1991 Corvette: Service Bulletin: Squeak and Rattle Diagnosis Guide

Subject: SQUEAK AND RATTLE DIAG. GUIDE DIAGNOSTIC AID/CORRECTION

Model and Year: 1991 CORVETTE

Bulletin Number: 91-264-10 - (03/25/1991)

FIGURE 1

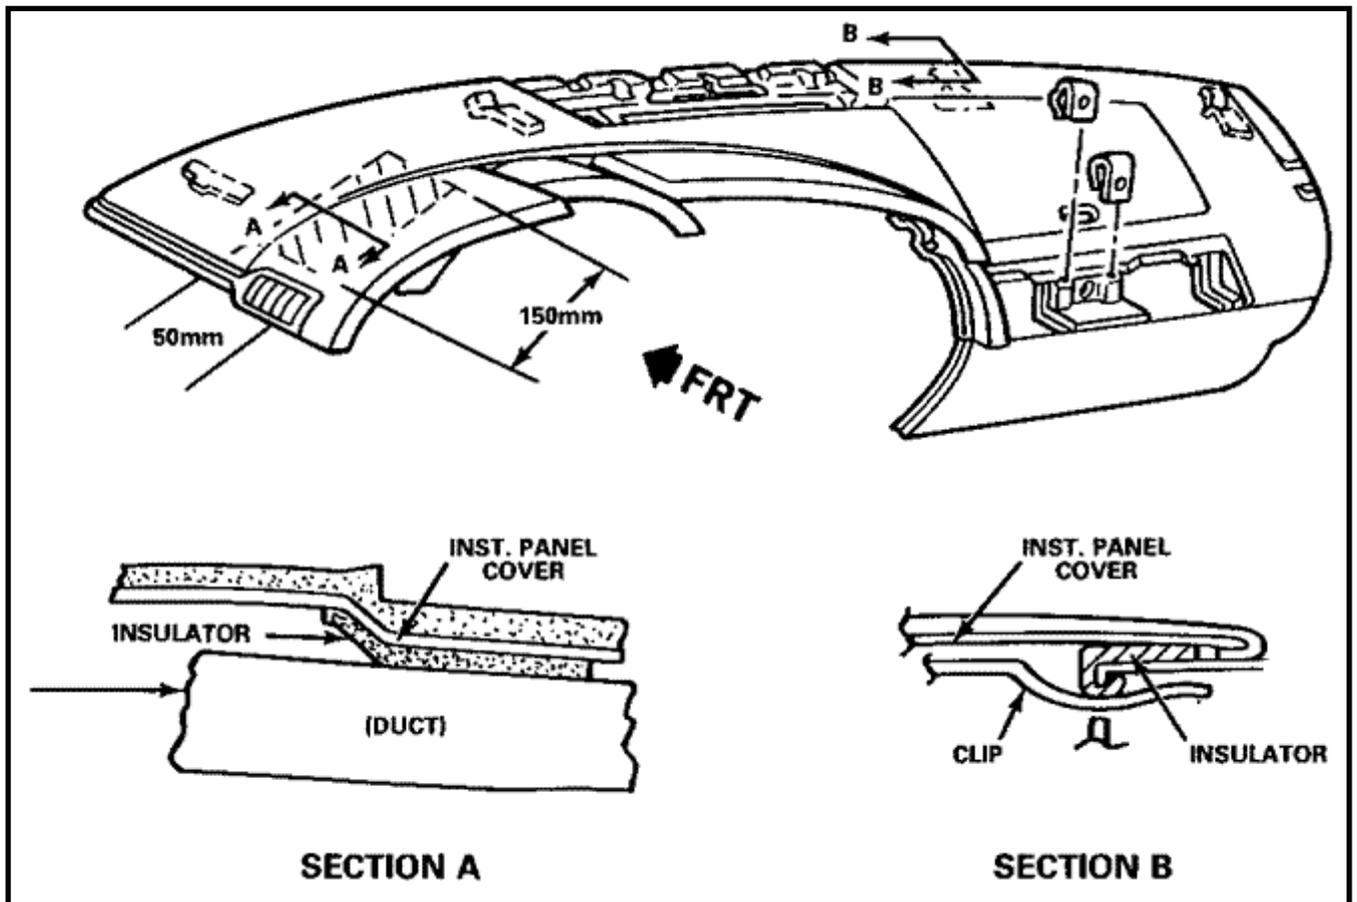
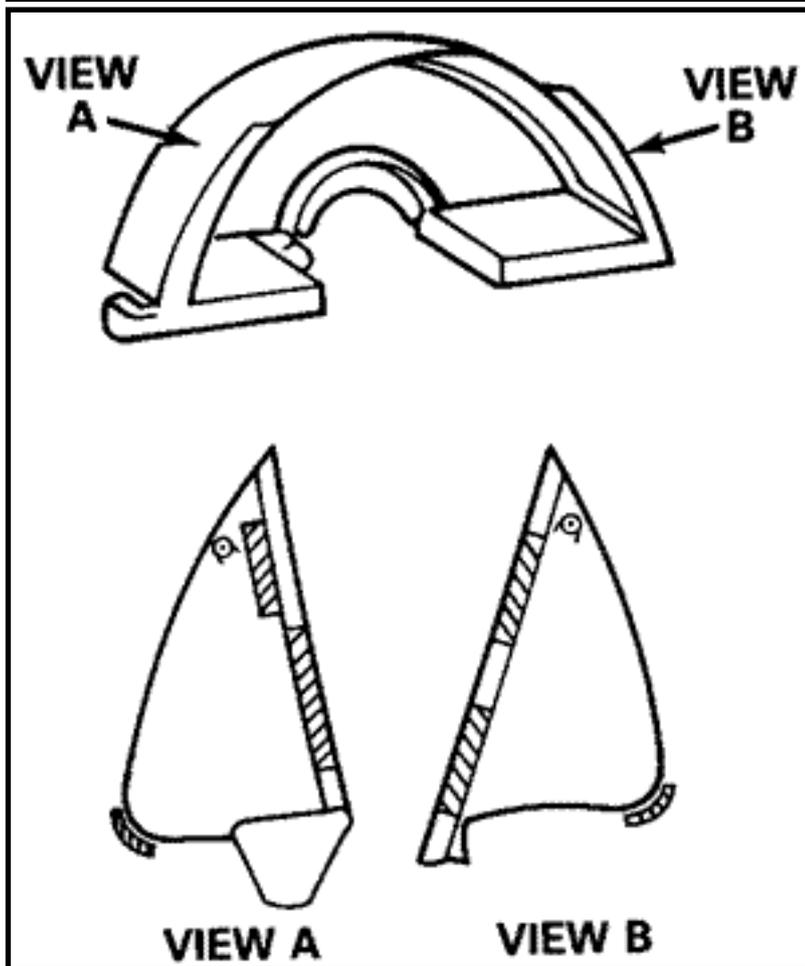
1. Rattle forward of gages cluster 1. Insulate area shown in Figure at A/C cross car duct. 1 and Figure 1, Section A (felt material).

2. Rattle at front edge of cover 2. Reposition existing, or near windshield. install felt insulators on metal opening at all retainers, (see Figure 1, Section B). - Left defogger outlet

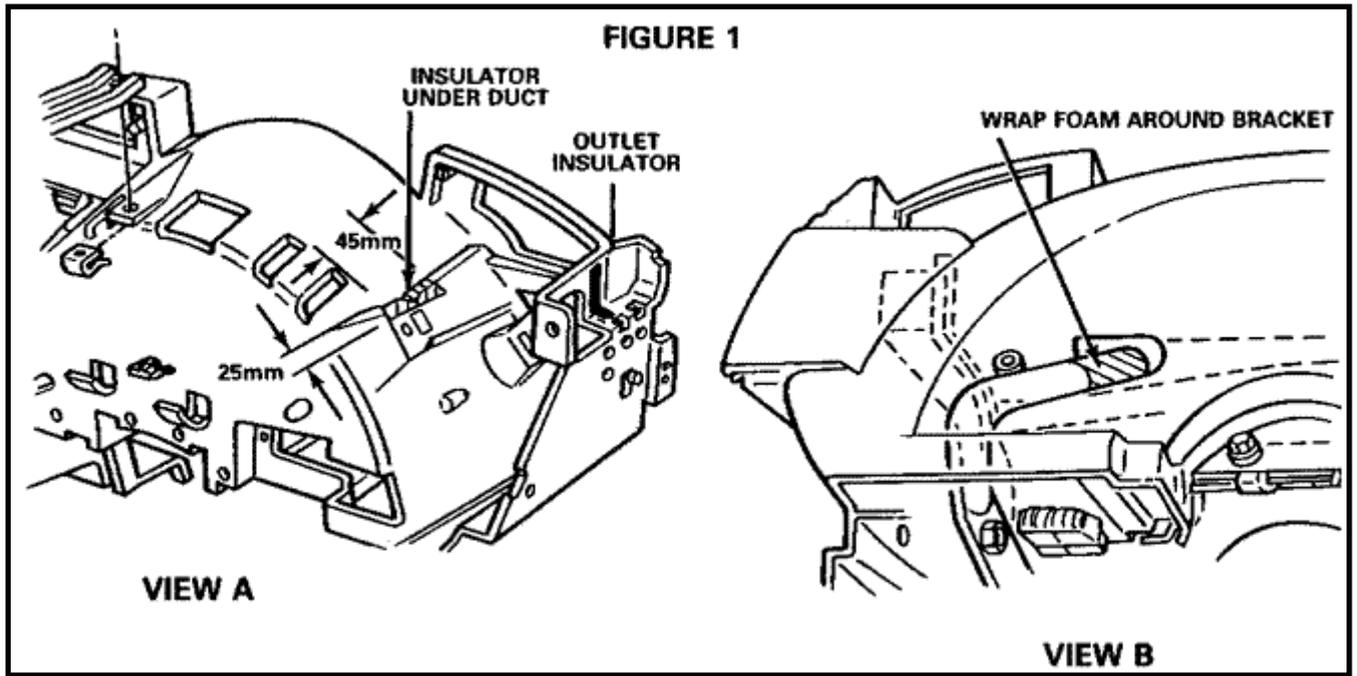
1. Buzzing against instrument 1. Apply felt insulator (1/2" X panel housing. 3"

as shown in Figure 2, view A). - A/C cross car duct

1. Rattle at top of instrument 1. Apply foam insulator (1/8") panel housing. to housing as shown in Figure 2, view A.

2. Rattle at left side SIR 2. Apply foam insulator (1/8") bracket. around bracket as shown in Figure 2 view B. - Instrumentation area

FIGURE 3

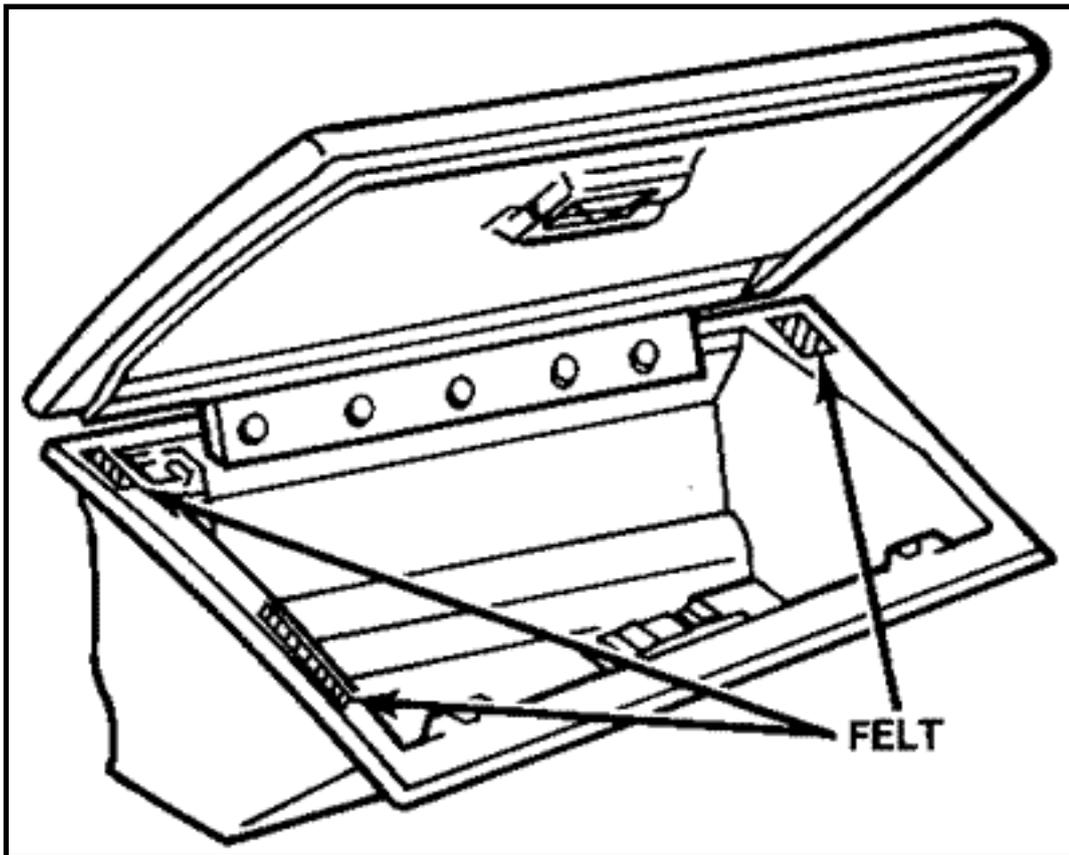
1. Squeak in instrument cluster 1. Apply felt insulators to bezel to cover. bezel edges and surfaces in locations as shown in Figure 3, views A and B.

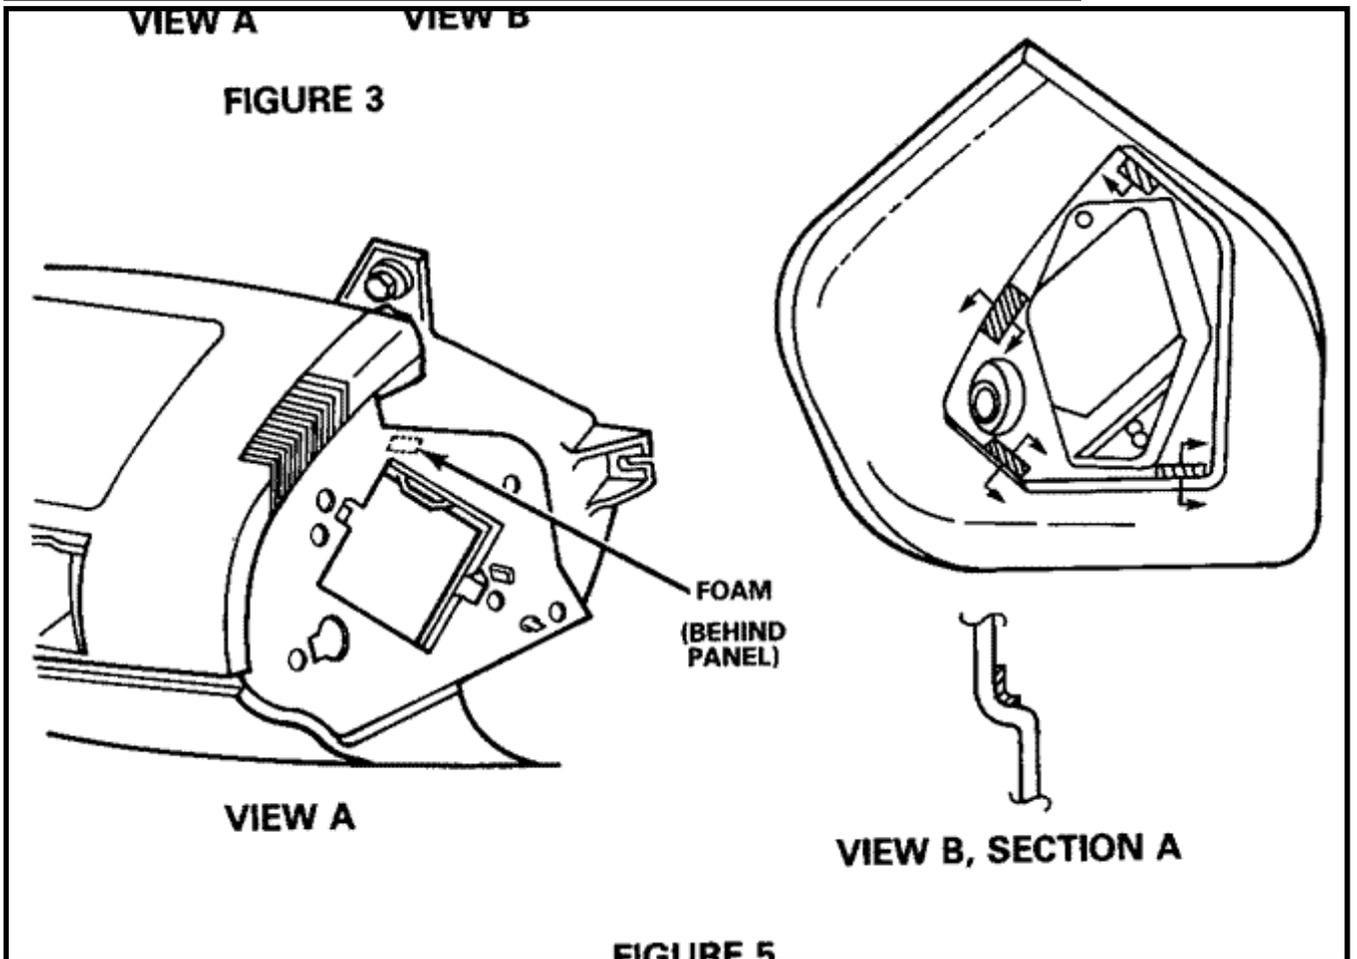
1. Rattle in glove box door to 1. Apply felt insulators as shown glove housing. in Figure 4, or in any contact area.

FIGURE 5

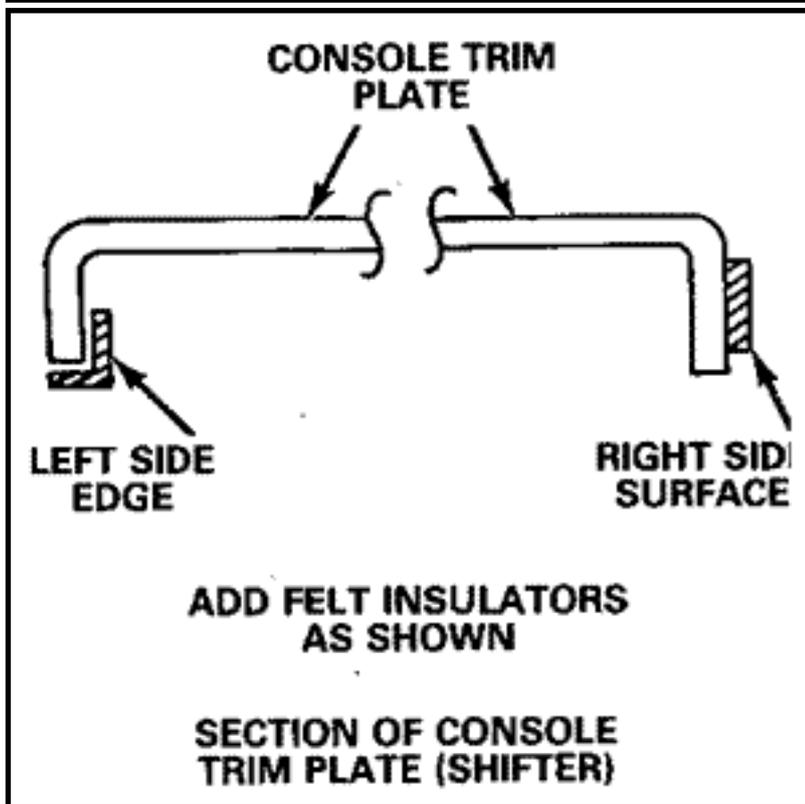
2. Buzzing of fuse box rivet 2. Apply small 1/4" foam heads to instrument panel insulator between rivet head cover. and cover as shown and cover as shown in Figure 5, view A.

3. Buzzing of fuse box door 3. Apply felt insulators (1/4" X in the opening. 1") as shown in Figure 5, view B. Position felt into the radius of the opening.

**REMOVABLE ROOF, FRONT
BOLT AND RETAINER**

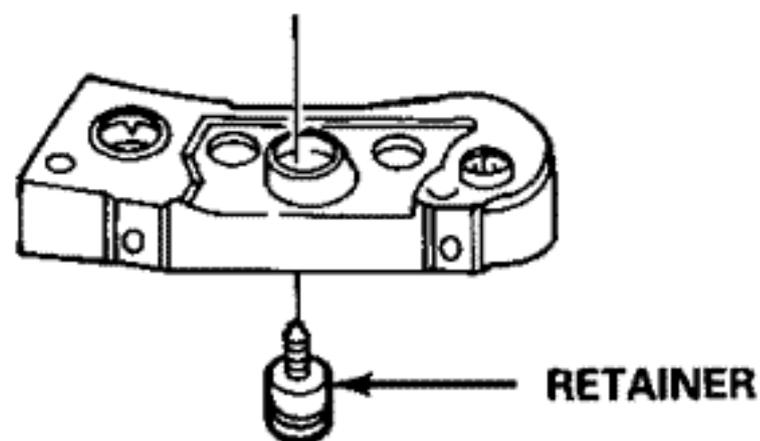
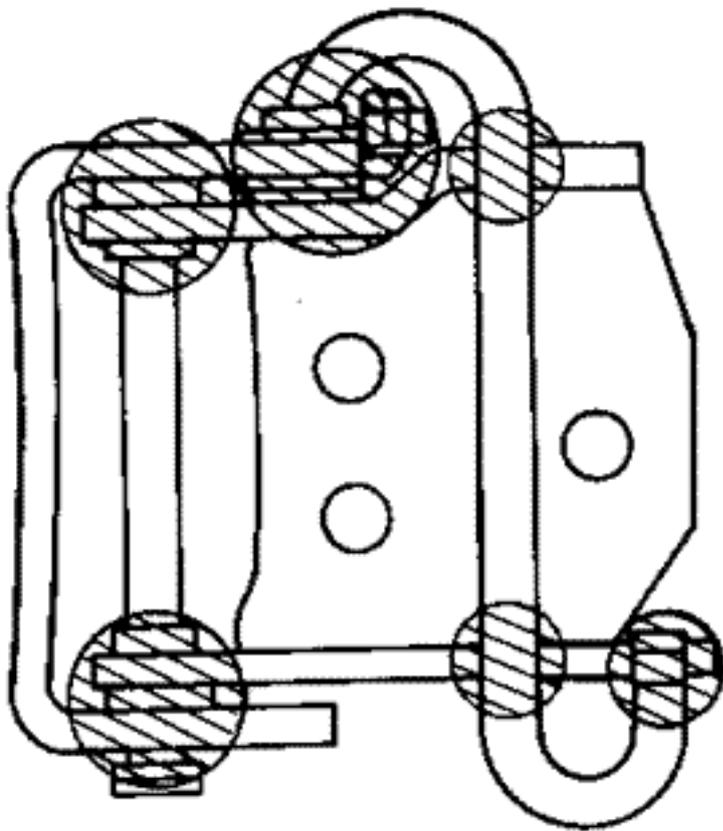
1. Rattle of front attaching bolts 1. Install new bolt retainers, when panel is stowed in rear. P/N 10 1 75804, see Figure 8.

1. Soak new retainers in warm water to aid in installation.
2. Remove roof panel and stow.
3. Remove upper trim covers at right and left latch areas.
4. Remove right and left sun visors, inside mirror and center garnish molding.
5. Carefully pry original retainer and bolt out of housing using a flat blade screwdriver or other suitable tool.
6. Install bolt in new retainer, align locating rib on retainer with notch in housing and press into place with a "C" clamp and socket.
7. Reinstall garnish molding, inside mirror, sun visors and upper trim covers.

- **PRY BOLT & RETAINER OUT
OF HOUSING WITH FLAT
BLADED SCREWDRIVER**
- **ALIGN LOCATING RIB WITH
NOTCH IN HOUSING**
- **PRESS INTO PLACE WITH
'C' CLAMP**

**LUBE AT SHADED AREAS
DOOR UPPER HINGE**

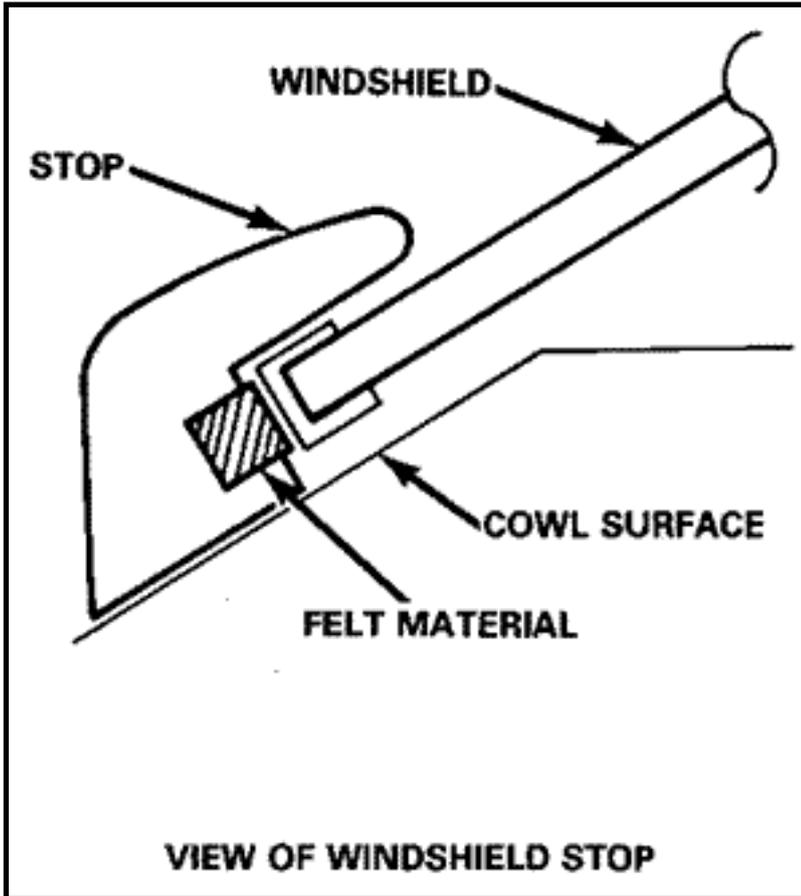
1. Squeaks when opening doors at 1. Lubricate ALL hinge torque hinge torque rod contact areas. rod contact areas with 30 wt. motor oil or grease, see Figure 9.
